Technical changes to the exhaust manifold, new EGR pipe and heat shield ?

Vehicle Manufacturer: VW

Vehicle: T6 2.0 tdi

Engine code: CXGA, CXGB

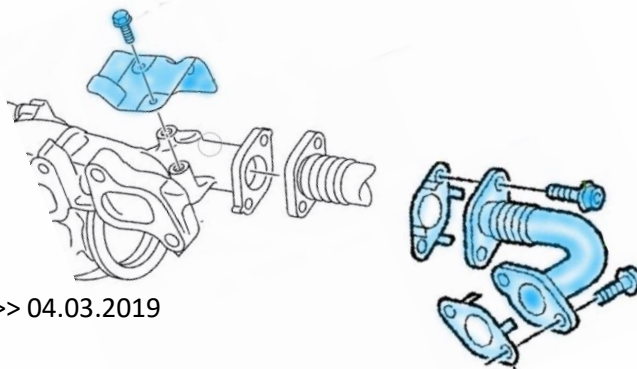
If the version marked in red has to be replaced, the following components are required by the vehicle manufacturer:

2x	106 884 02	screw M6x8
1x	03N 145 811 B	heatshield
2x	03L 131 547 P	gasket
2x	N 910 461 01	screw M8x22
2x	N 910 268 02	screw M8x20

1x	04L 131 521 AK	EGR connecting pipe	>> 04.03.2019
or			
1x	04L 131 521 BF	EGR-connecting pipe	04.03.2019 >>

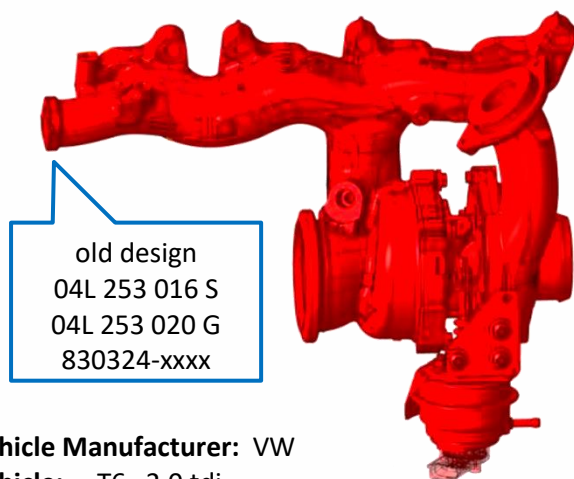
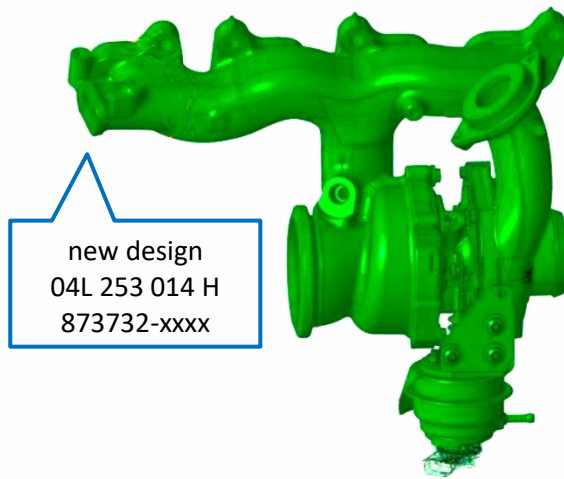
old design
04L 253 016 S
04L 253 020 G
830324-xxxx

new design
04L 253 014 H
873732-xxxx
